BUILDING PERMIT REPORT

ADDRESS: 22-24 Deering AVE

REASON FOR PERMIT: Change of Use 6 to 4
Dwelling Units

This is in further reference to your application for a building permit to change a six unit building at 22-24 Deering Avenue to a four apartment unit building, thereby complying with the density for the R-6 Residence Zone.

New floor plan

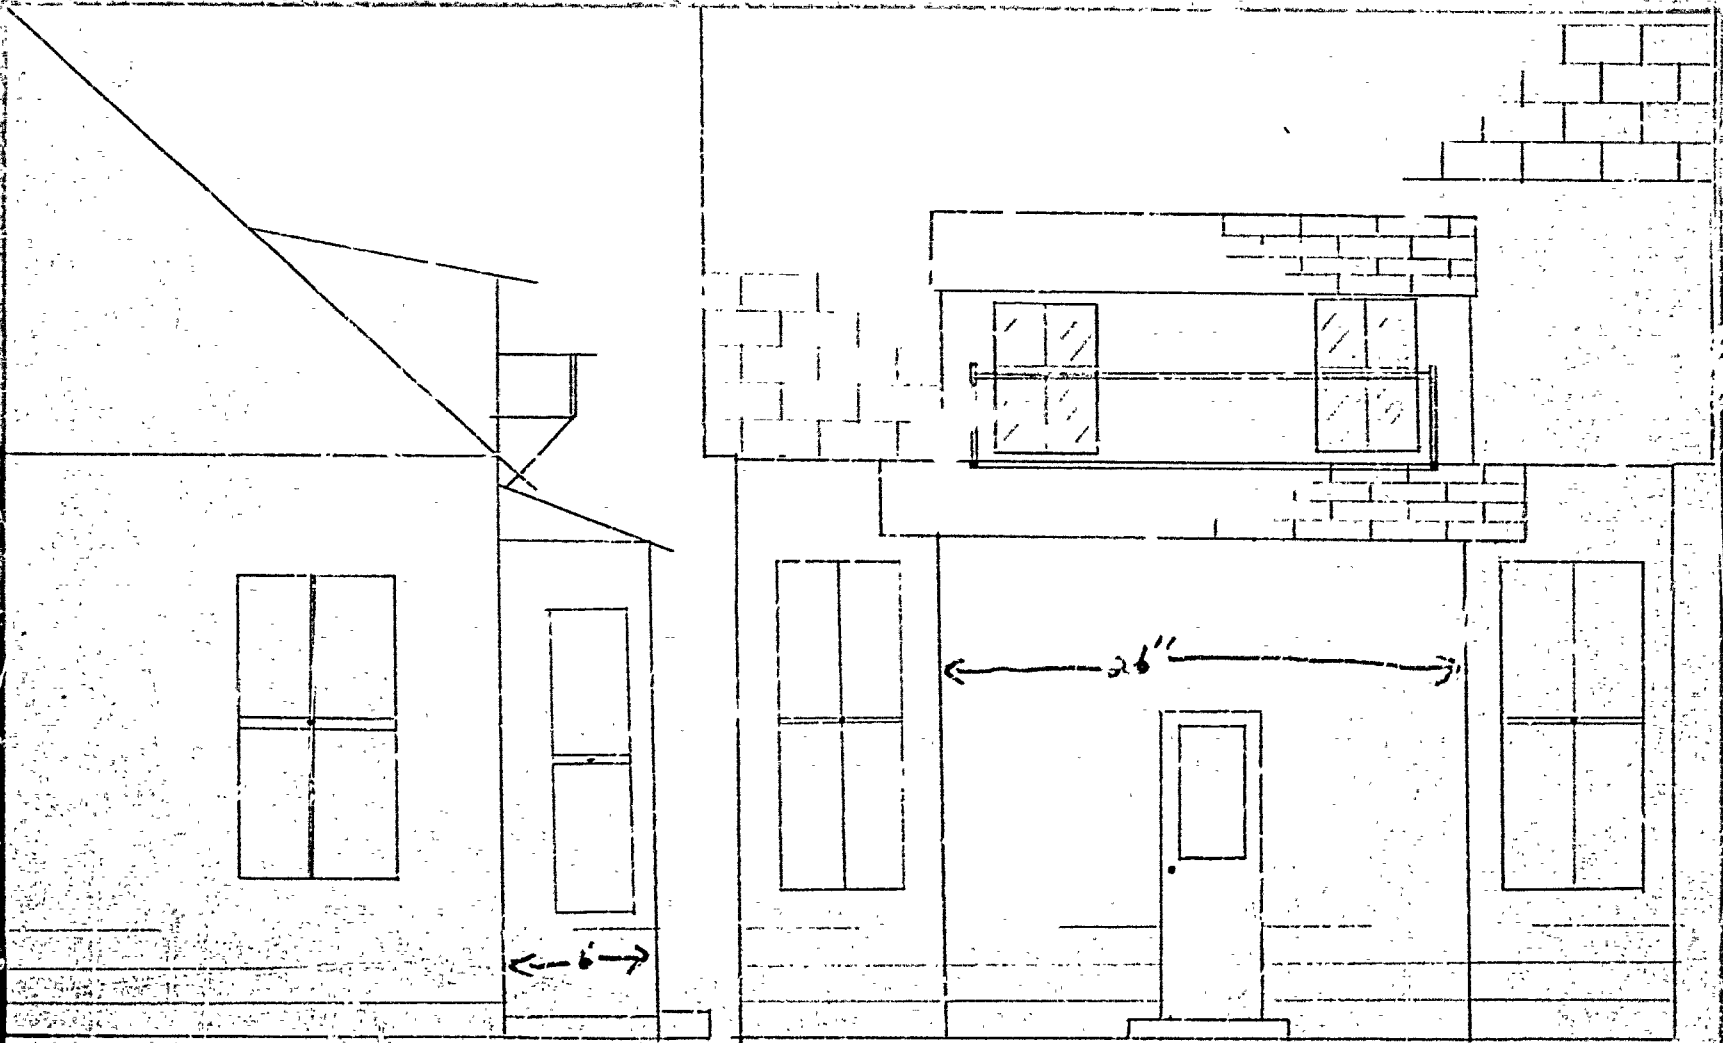
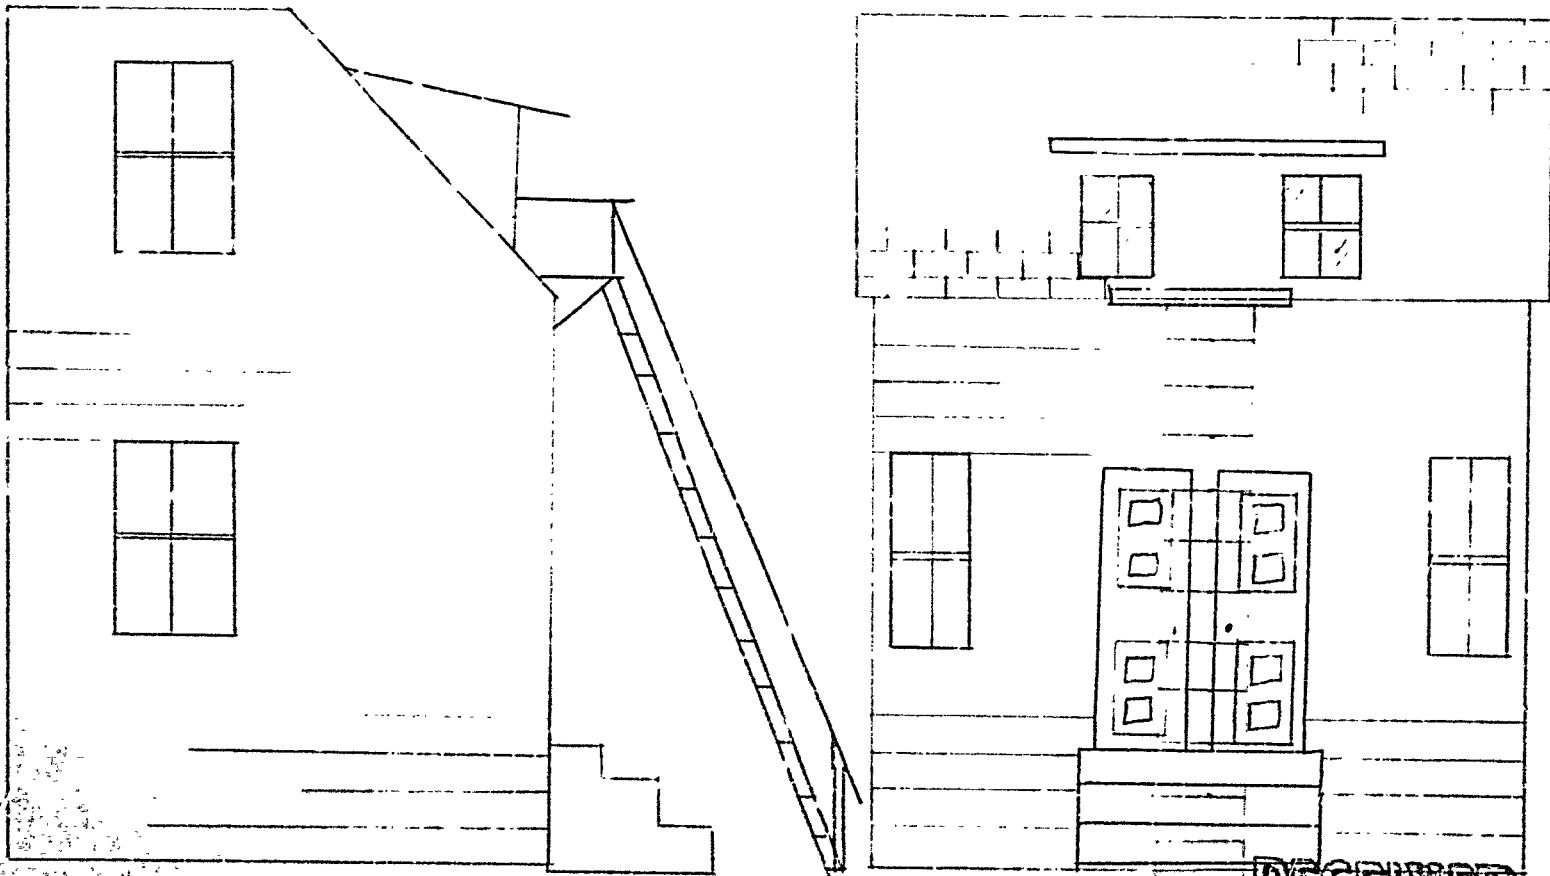
The building is very different from proposed plans.

- Ex. 1.) fire escape has been removed.
2.) rear two doors have been nailed + boarded up
3.) No 6'x6' addition as in plan
4.) proposed Basement units show rear hallway... none.

* This is also a 5 unit (Cathy Ames told me there was no kitchen in top unit. However there is.
